# FEC degrade signaling using service interface

Matt Brown, Alphawave  
Eugene Opsasnick, Broadcom  
Gary Nicholl, Cisco  
Adee Ran, Cisco  
Xiang He, Huawei  
Kapil Shrikhande, Marvell

# Proposed changes to the Draft

## Detailed view - current specification

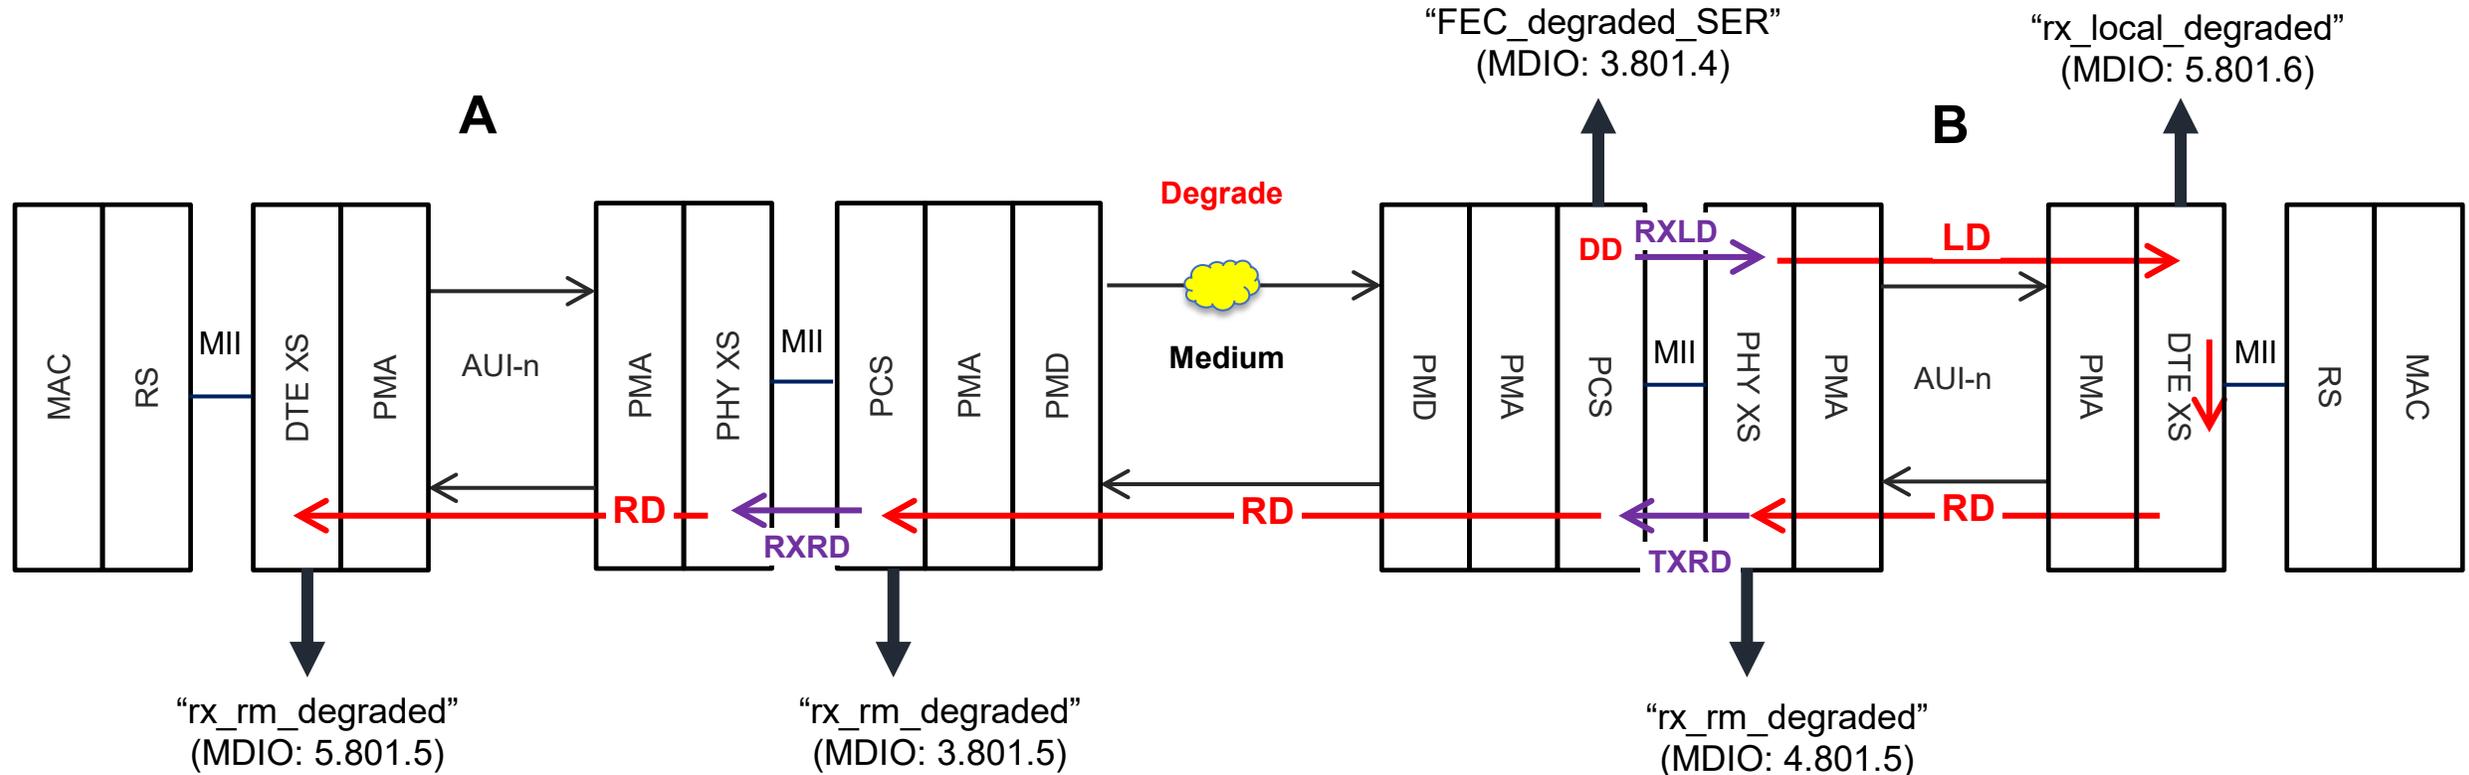
The PHY XS sets the alignment marker status field based upon status variable in the PCS below, rather than through service interface signals from the PCS.

The PCS sets the alignment marker status field based upon status variables in the PHY XS above, rather than through service interface signals from the PHY XS.

# Proposal Summary

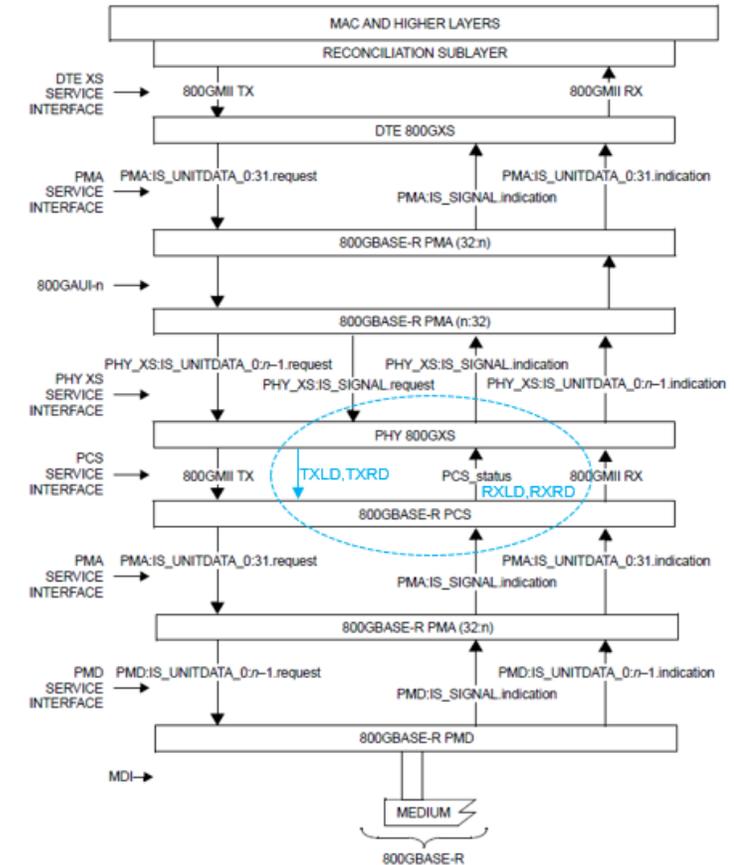
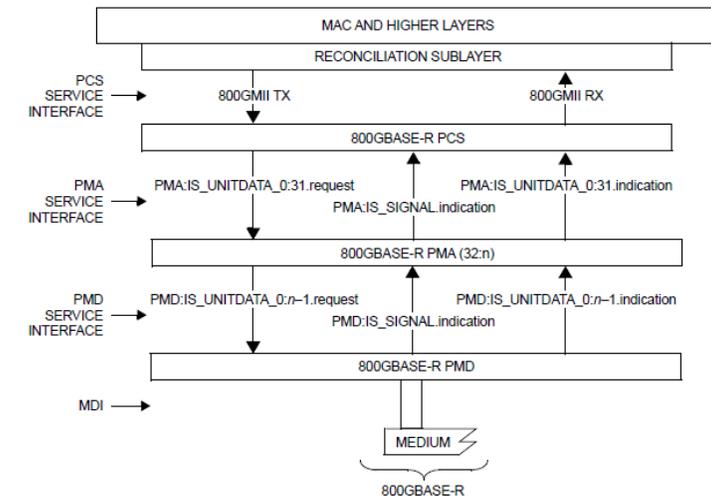
Add four new signals to the “PCS service interface” when the sublayer above the PCS is a PHY XS.

- TXLD = PHY\_XS:FEC\_degraded\_SER
- TXRD = PHY\_XS:rx\_rm\_degraded
- RXLD = PCS:FEC\_degraded\_SER + PCS:rx\_local\_degraded
- RXRD = PCS:rx\_rm\_degraded

When there is a PHY XS above the PCS, the PCS sets the FEC degrade signaling in the alignment marker status field (towards the medium) as follows:

- tx\_am\_sf<2> = TXRD
- tx\_am\_sf<1> = TXLD

The PHY XS sets the FEC degrade signaling in the alignment marker status field (towards the MAC) as follows:

- tx\_am\_sf<2> = RXRD
- tx\_am\_sf<1> = RXLD

Figure 169-3—800GBASE-R inter-sublayer service interfaces including 800GMII

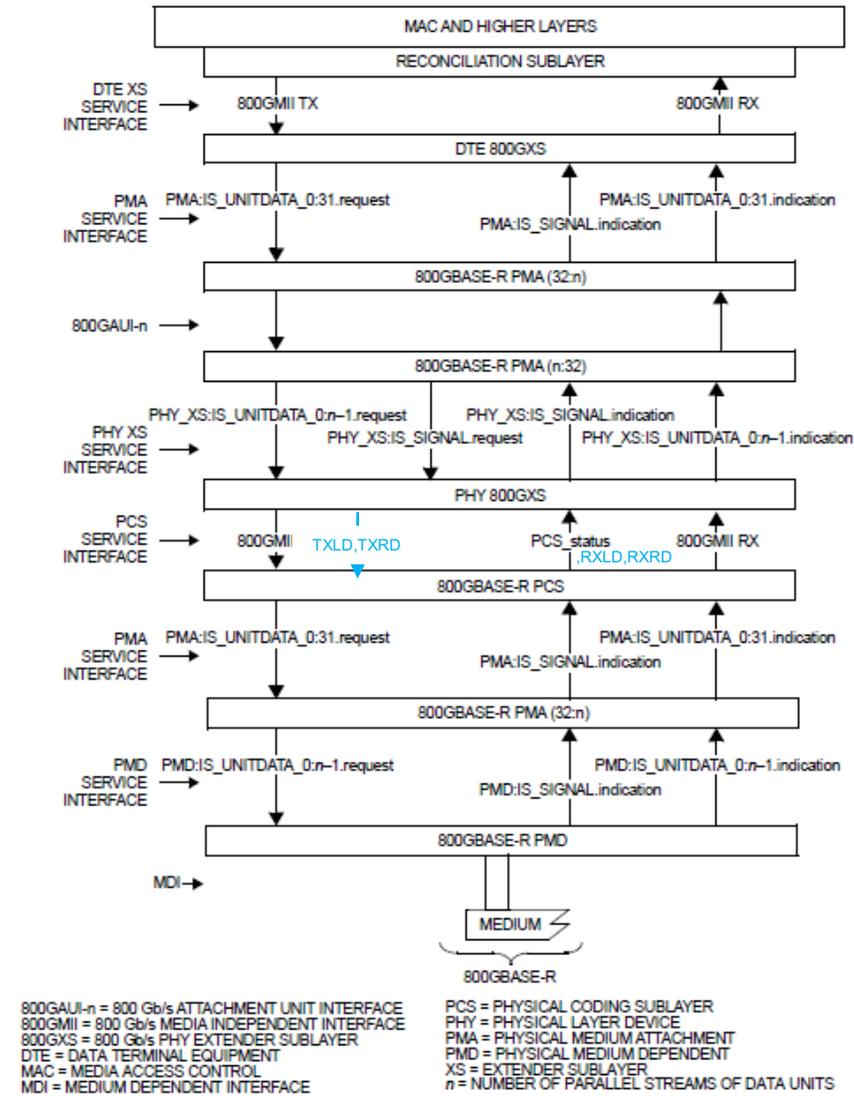
Update Figure 169-2 as follows, showing the new service interface signals indicating remote degrade (TXRD, RXRD) and local degrade (TXLD, RXLD).

Figure 172-2—Functional block diagram

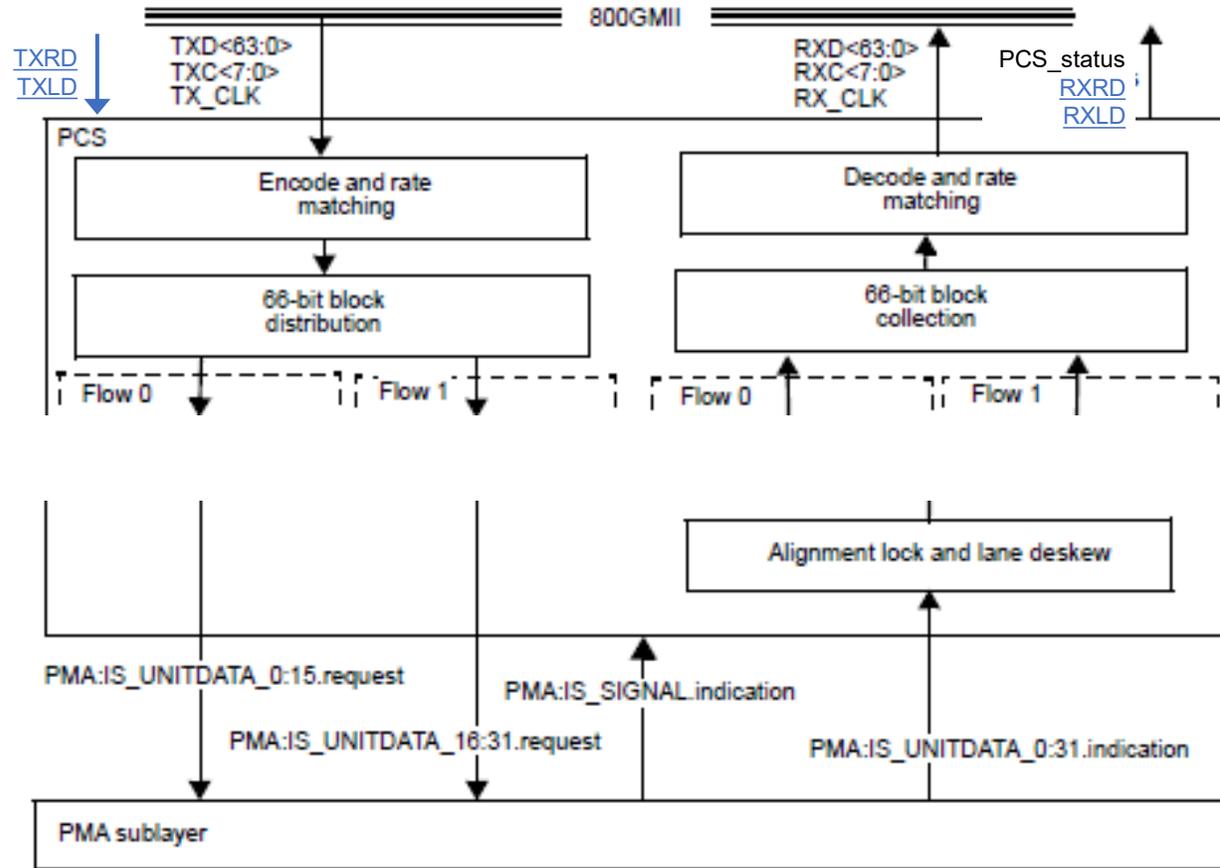
Update Figure 172-2 as follows, showing the new service interface signals indicating remote degrade (TXRD, RXRD) and local degrade (TXLD, RXLD).

Figure 171-2—Functional block diagram for the PHY 800GXS

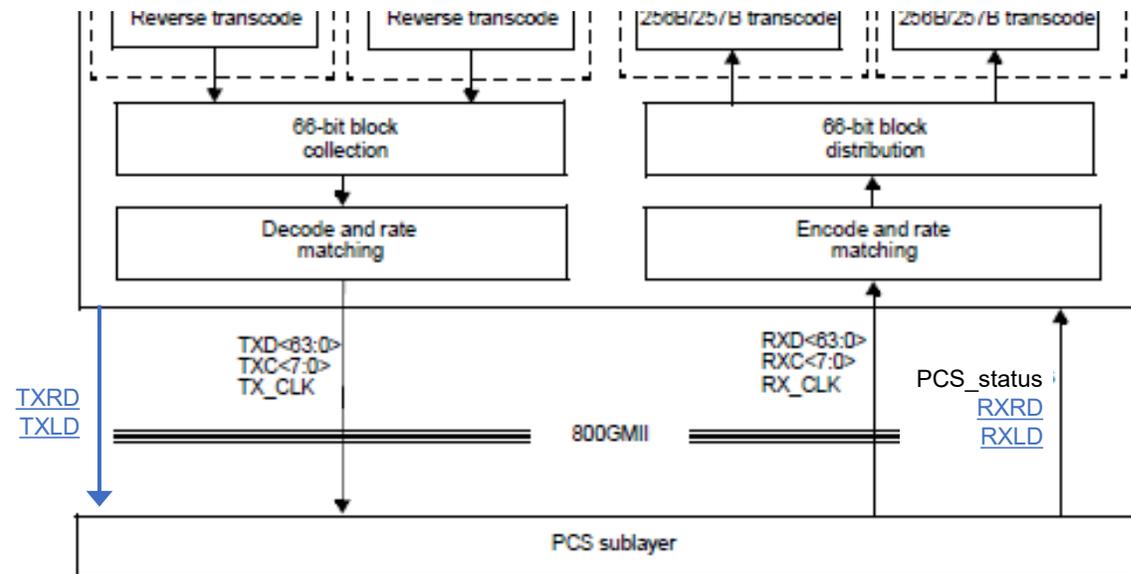
Update Figure 171-2 as follows, showing new signals indicating remote degrade (TXRD, RXRD) and local degrade (TXLD, RXLD).
